## Bulletin

**Application:** General Motors 4T40E / 4T45E 2004-Up  
**Subject:** Valve Body Gasket Revision

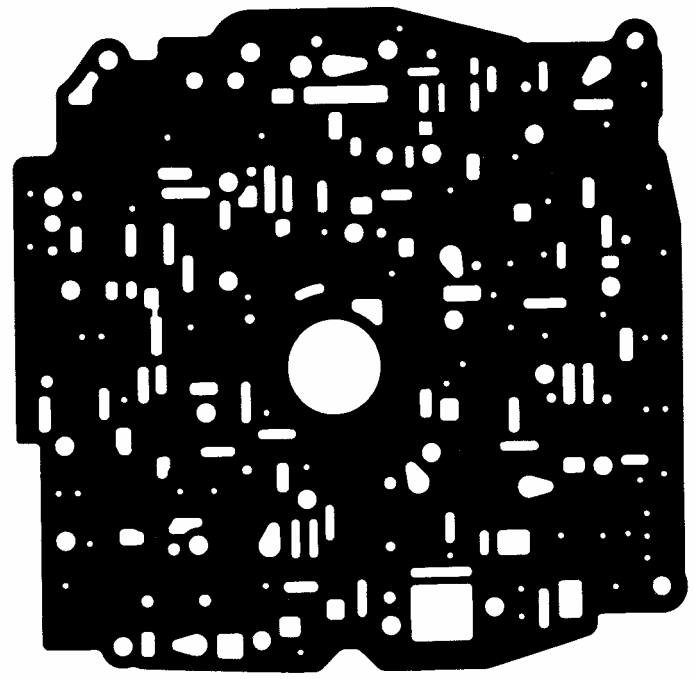
There has been a revision in the valve body gaskets of the 4T40E/4T45E for model year 2004. Due to major changes in the gaskets and separator plate, there is no possibility for a retrofit.

The new gaskets, TransTec #36173 (lower) and #36174 (upper), will service only 2004-up models of this unit. A white stripe has been added to the late model gaskets for easy identification. The OEM numbers are stamped into each gasket as well.

LOWER, WITH TAB  
TRANSTEC #36173  
(OEM #24216017)

UPPER, NO TAB  
TRANSTEC #36174  
(OEM #24216019)
